Keyless Programming Switch Wiring

Bulletin Type:	SRP	Publication Date:	January 2024
Bulletin #(s):	24-002	Make(s):	Entegra Coach
Job Code(s):	<i>If affected unit has warranty remaining, submit your claim following the normal process</i>	Model(s):	Cornerstone, Anthem, and Aspire
Flat Rate(s):		Model Year(s):	2023-2024

Incident:	Keyless Entry Programming Switch Wiring
Affected Units:	Certain Entegra Coach 2023-2024 Cornerstone, Anthem, and Aspire
Misc. Tools & Supplies:	Screw gun with square bit

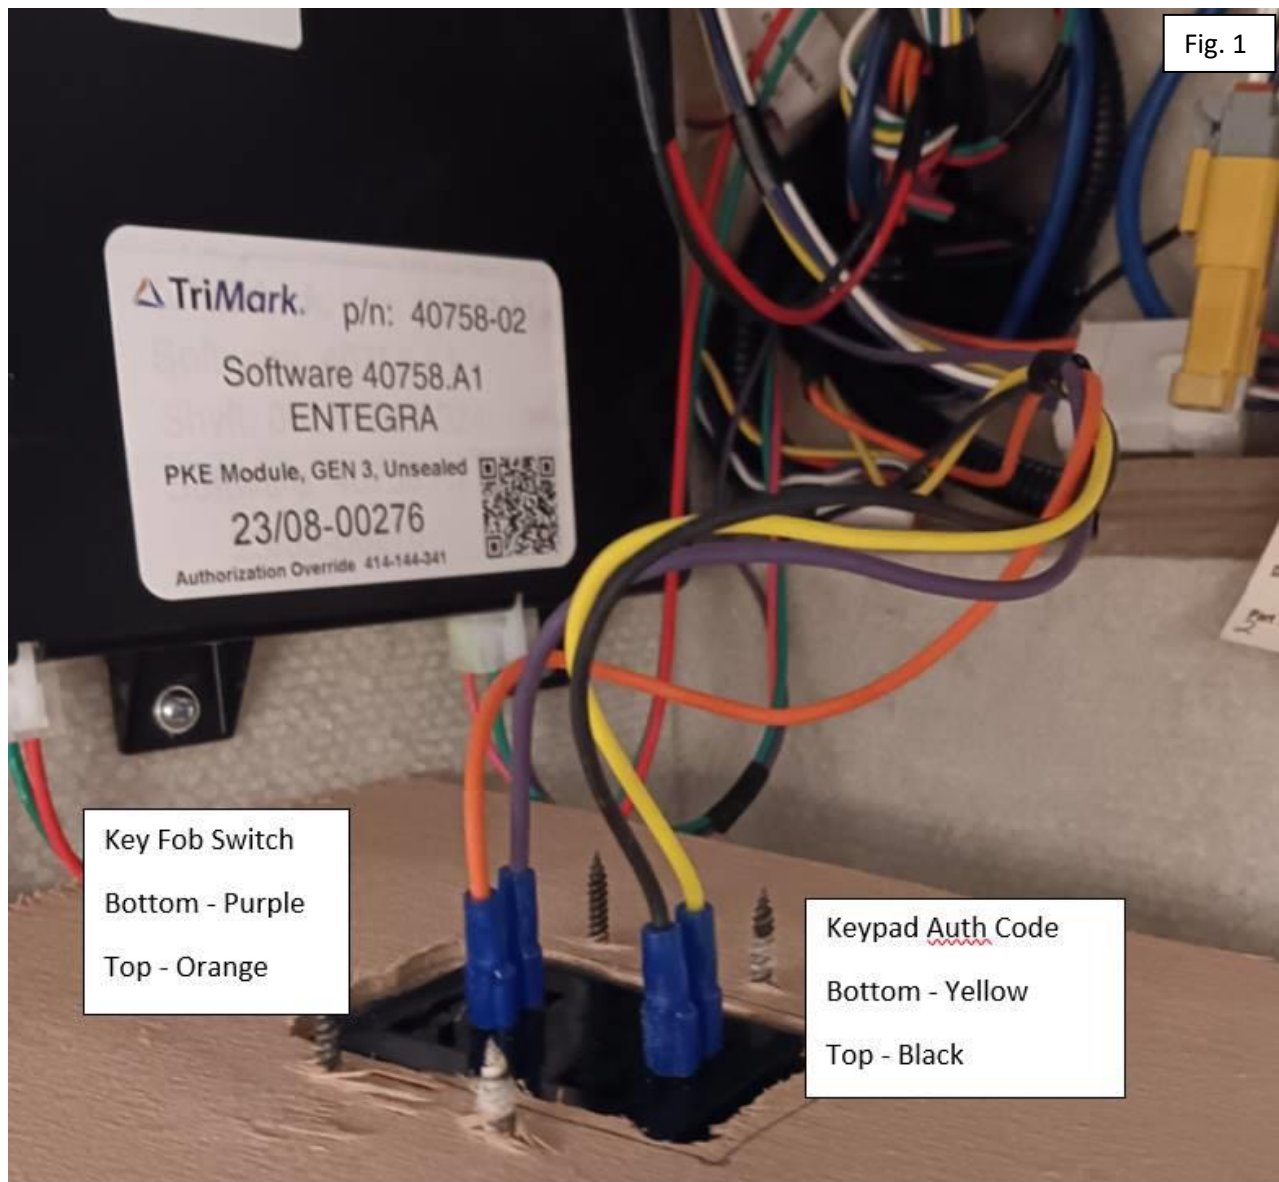
1. Inspect the back of the keyless entry programming switches labeled “Key Fob” and “Keypad Auth. Code”. Switches are located inside the driver’s front overhead cabinet.
2. Remove screws holding panel that switches are mounted to.
3. Tilt panel down enough to inspect back of the switches.
4. Inspect wires to the switches, the wires should match Figure 1.
 - a. If wires DO NOT match move to step 5.
 - b. No further action is required if wires DO match.
5. Remove wires from switches. When removing wires pull from the blue slide connectors in the picture. DO NOT pull on wires themselves.
6. Attach wires to the switches following the label in the below picture.
7. Replace panel in place and secure with screws.
